**CITY OF NEWPORT BEACH  
COMMUNITY DEVELOPMENT DEPARTMENT  
PLANNING DIVISION ACTION REPORT**

**Subject:** Uptown Newport Residential Condominiums (PA2021-120)  
▪ Minor Site Development Review No. SD2021-002

**Site Location** 4288 Half Dome Place

#	Comment	Resolution
<b>PLANNING COMMENTS</b>		
<b>1</b>	<b>Project Description</b>	
1.a	Off road parking vs. "All parking shall be provided on site"	All parking has been provided on site. Street parking has been shown for information only. Project narrative and sheet A1-100 - Site Plan have been revised

**Figure 11: Balconies (red highlighted areas) where noise control measures are required on second through sixth floors.**

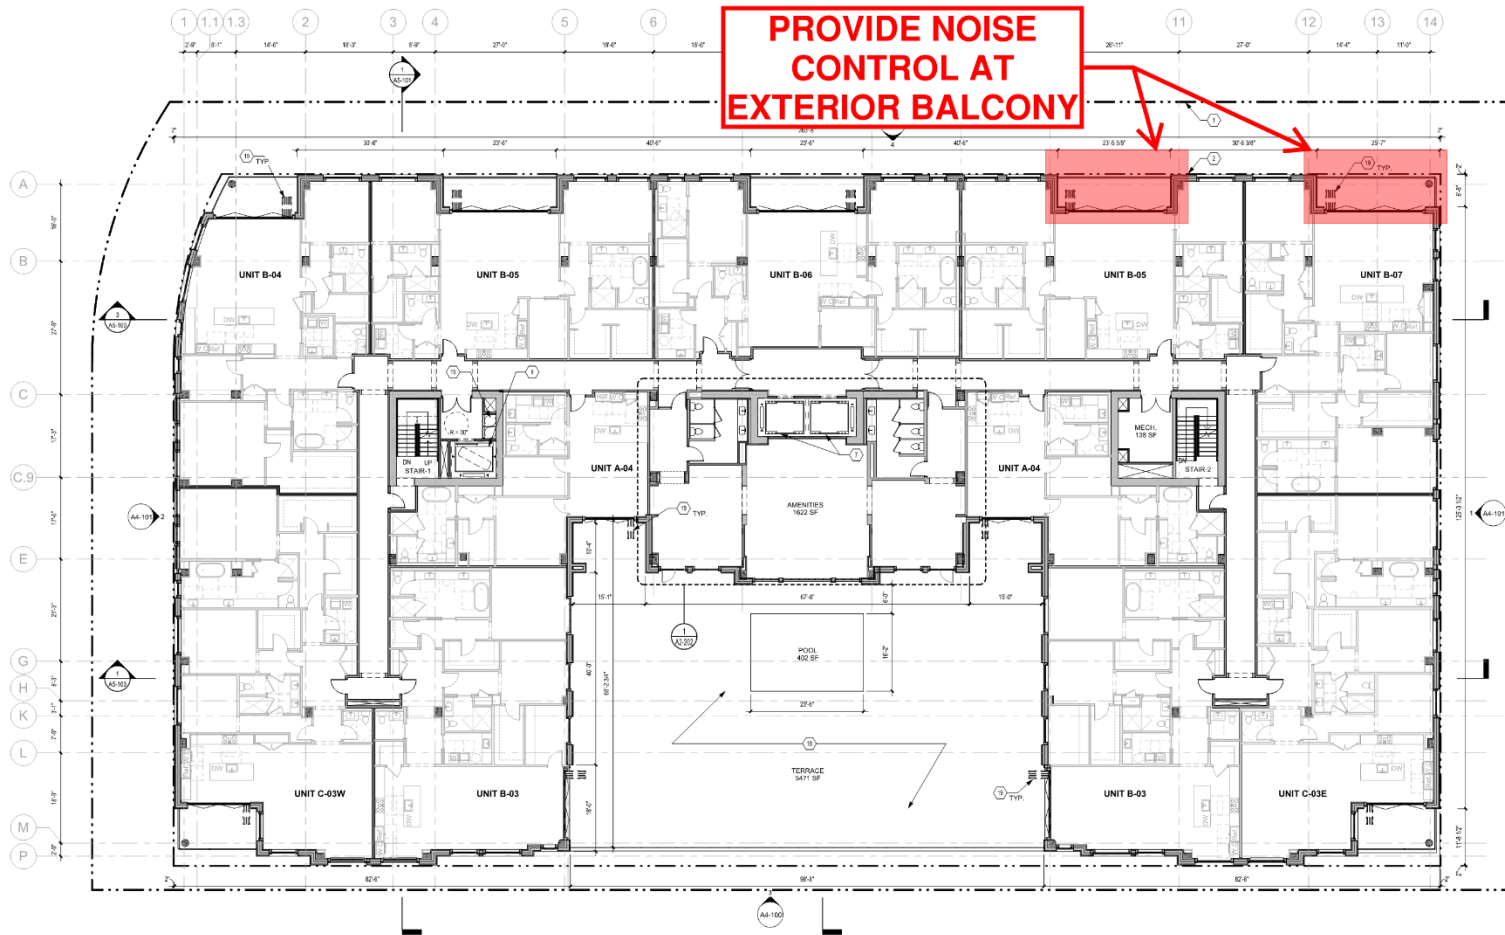
To achieve the Mitigation Measure 10-3 65 CNEL noise standard at the balconies, noise control measures will be required at those with direct exposure to the Tower Jazz facility (project north and east). See Figure 11 for the approximate locations of the balconies where the following noise control measures are recommended. Figure 12 shows schematic placement of the noise control recommendations.

**Figure 13: Acoustical isolation of electrical boxes and other recessed elements at exterior walls.**

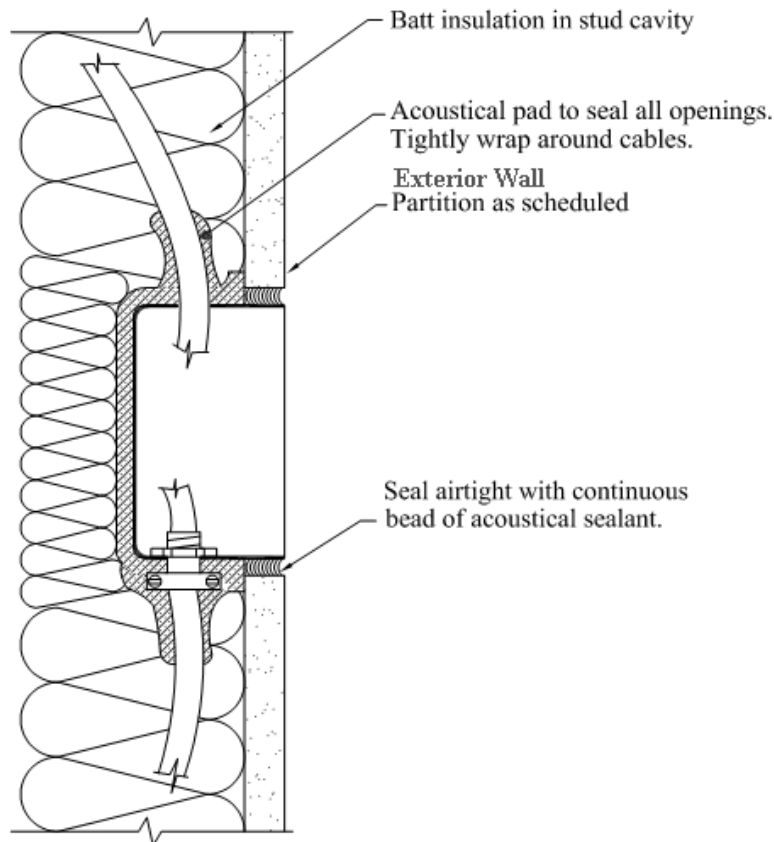
Apply outlet box pads and caulk to all electrical boxes in exterior walls (both interior and exterior faces), as one would in all corridor, party and other sound rated interior partitions (including floor-ceiling assemblies). Thoroughly caulk around all edges of electrical outlet boxes and other penetrations with non-hardening acoustical sealant. See schematic detail in Figure 13.

**Figure 6: Typical resilient channel installation details**

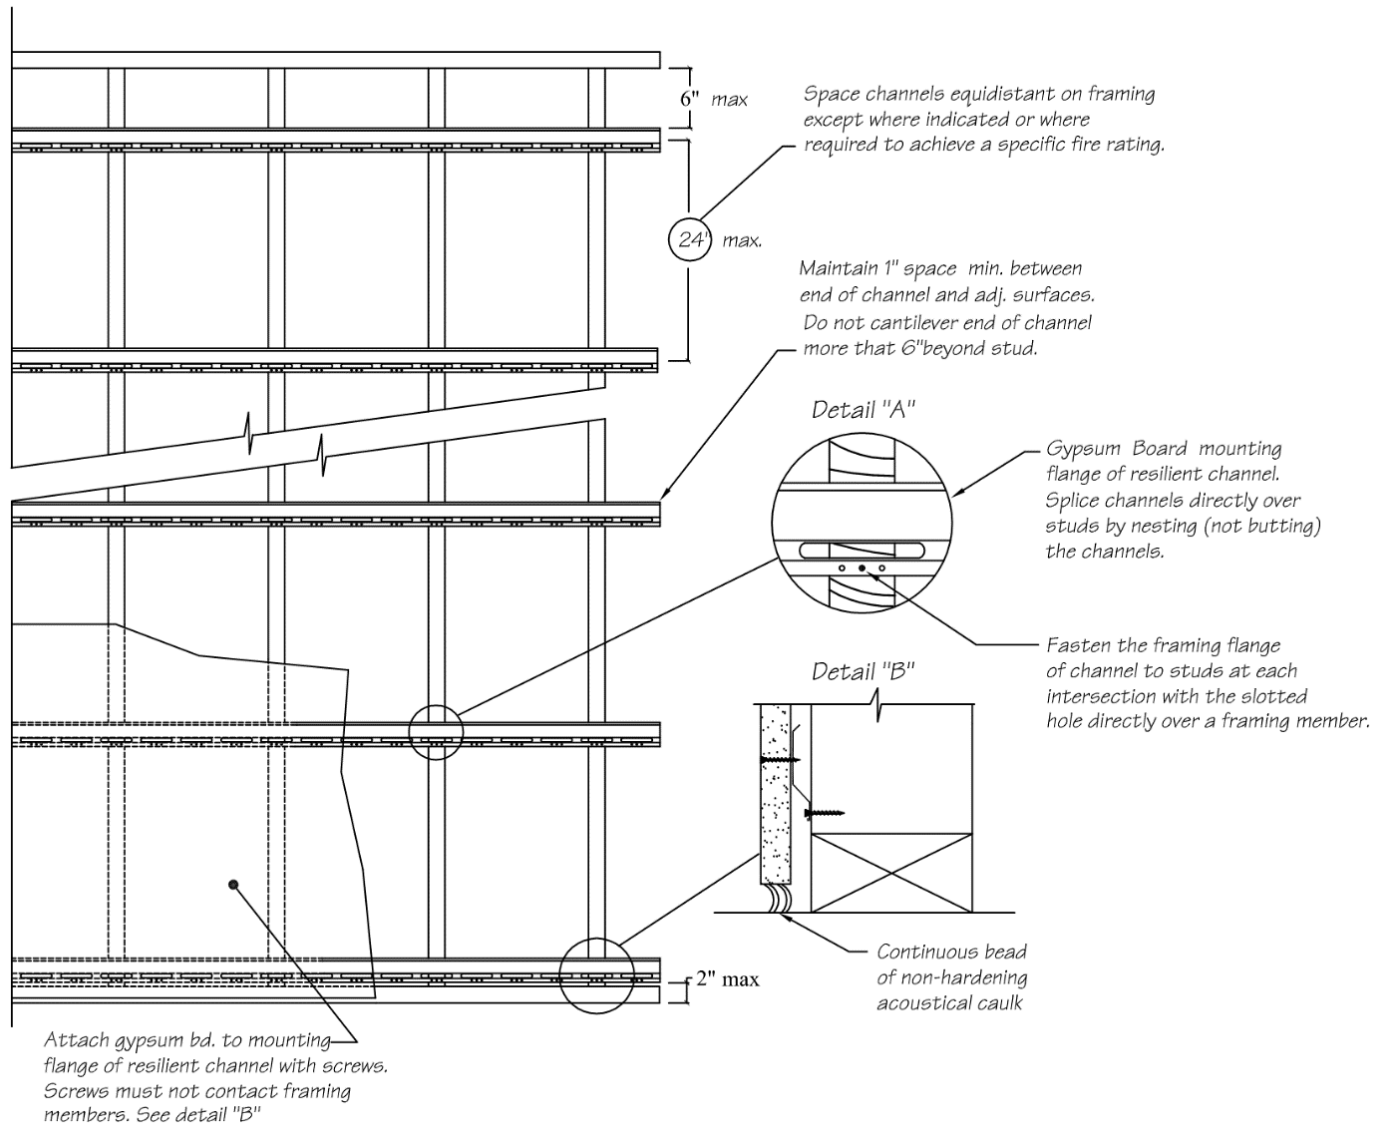
2. At walls, position resilient channels at right angles to studs with the narrow flange down and the wide flange (free edge) up. Use the manufacturer provided hole in the narrow flange to fasten channels to studs, aligning the open slots in the web with the studs, if possible. Fasten channels to studs with 1" Type S screws or 1-1/4" Type S or Type W screws, as per fire code requirements. Do not use nails. See Figure 6 for typical installation details.
